APPENDIX H

MINUTES OF DISCUSSIONS

MEMORANDUM

PROJECT FOR CONSTRUCTION OF THE NEW DIROUT GROUP OF
REGULATORS

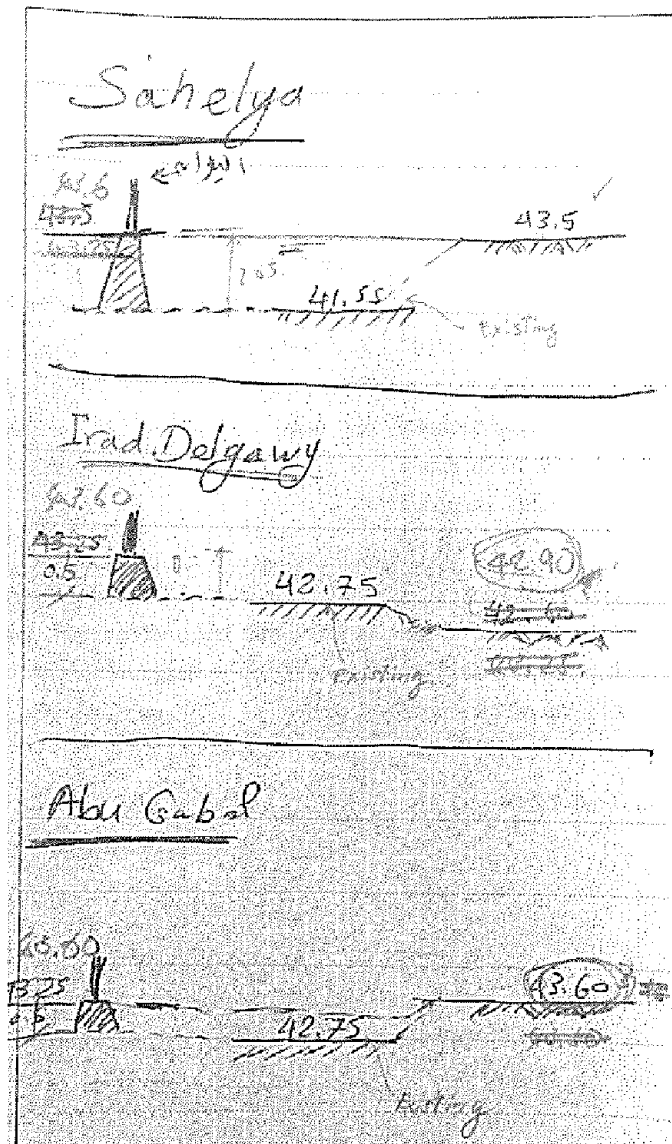
In the meeting RGSB drew the new suggested canal cross sections which they can approve, and showed it to D/D consultant (refer to the picture on the next page).

WG members and D/D consultants agreed that D/D consultant will make a new calculation under the condition of new DS canal cross section which was suggested by WG members.
